From: Ellison, Mark
Sent: 27 October 2022 14:27
To: Altman, Rebecca
Cc: Griffin, Tim
Subject: RE: DC/22/93827 Land at Villeneuve St George Way, Eastleigh - landscape comments

I have been asked to provide landscape comments on this discharge of conditions application.

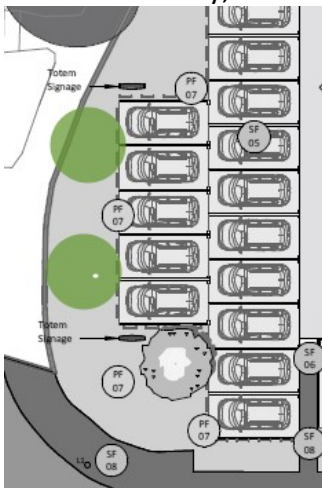
At this stage, I am looking for assurances that all the tree planting indicated on the landscape plans will be deliverable. In particular, please ask the applicant to confirm that the existing drainage and proposed lighting columns will not lead to any omissions of new trees along Villeneuve Way.

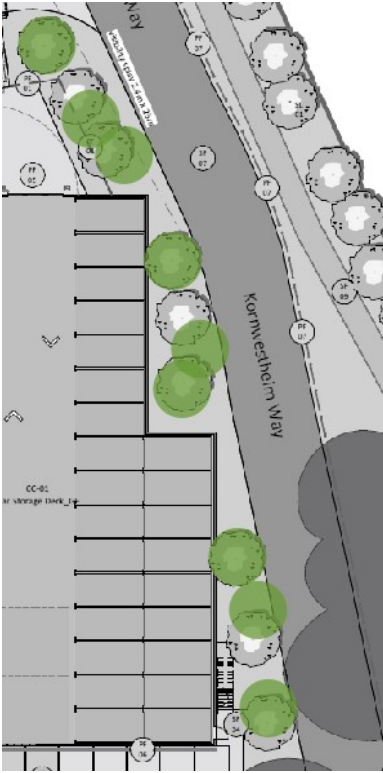
c/ It is disappointing that my earlier comment regarding additional tree planting along the Leigh Road frontage has not yet been accommodated. I can see no good reason why 2 further trees cannot be planted between the totem signs (see extract below). I understand that Hendy may wish for maximum visibility of their new facility, however, this development is at a scale that cannot be missed.

The more easterly totem sign seems excessive, especially as it will be partly hidden behind the existing trees along Leigh Road. Perhaps a single totem sign is sufficient.

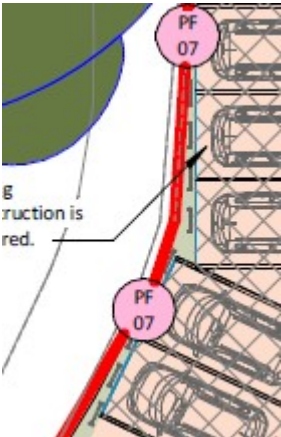
d/ The tree planting along the rear to screen the parking deck is intended to have a more naturalistic feel. Please adjust the tree positions as below for an informal effect.

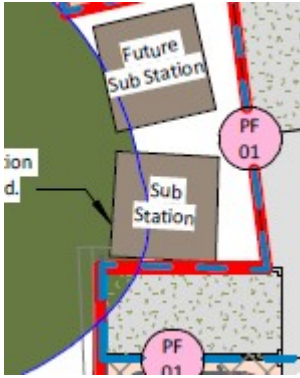
g/ Any thin strips of soft landscape (such as areas below) are too narrow for planting. Please replace with suitable hard landscape alternative.

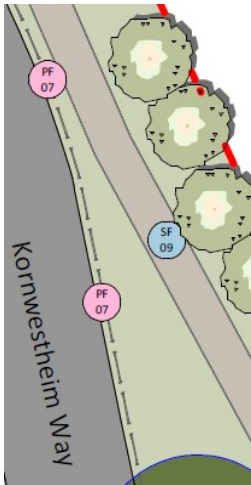
h/ Is there scope to omit this space adjacent the sub stn. and replace with screen planting? It will be a very tight space to access and inaccessible when the gates are open.

Sub. stns. are intrusive in views, so planting here would be welcomed.

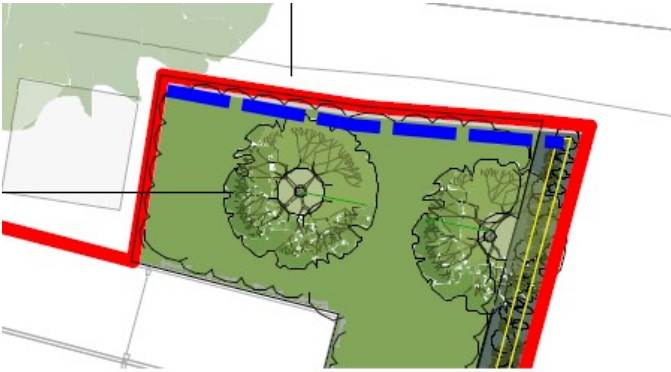
j/ I note a hooped perimeter barrier PF07 is proposed along the length of the Gateway footpath.

I need to check with Mark, but my own view would be that this is not the best detail here as it implies this area is part of Hendy Fords site, rather than reflecting the character of the adjacent Fleming Park. I would have thought a steel post, or a bespoke knee rail detail, would be more appropriate here (steel for longevity). A series of posts would be less visually intrusive. I think there is a low earth berm along this edge at the moment.

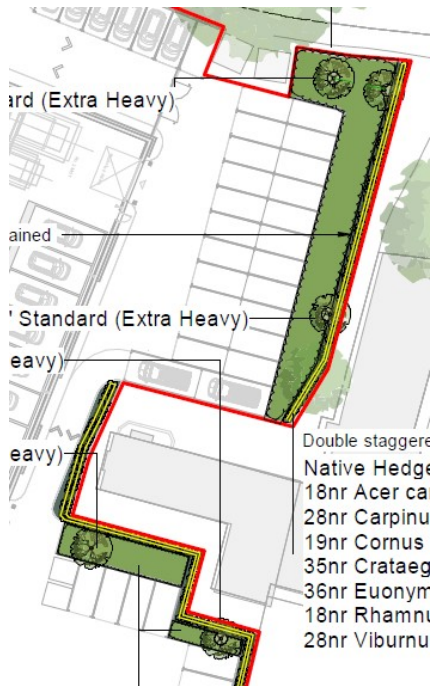
g/ Add note to plan - an alternative to *Ilex crenata* hedging - *Euonymus japonicus* 'Jean Hughes'.

Tree Pits Details

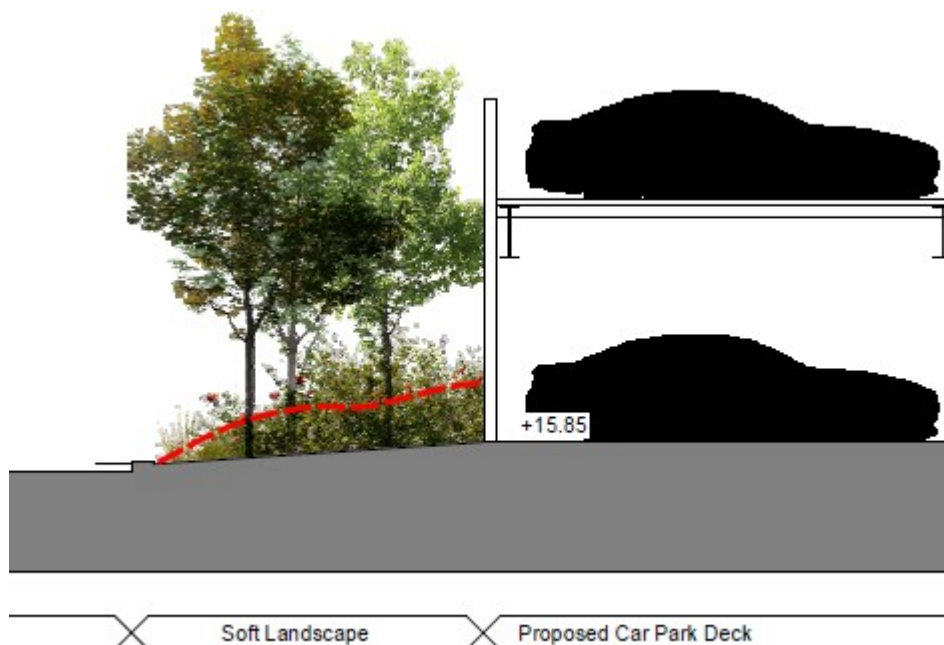
a/ Check labelling on tree pit sections - labels missing include topsoil layer, bark mulch, staking, irrigation pipes etc. Are any ameliorants/fertiliser being added to the topsoil backfill? Irrigation pipes to be placed around the **edge of the pit** not the edge of the rootball.
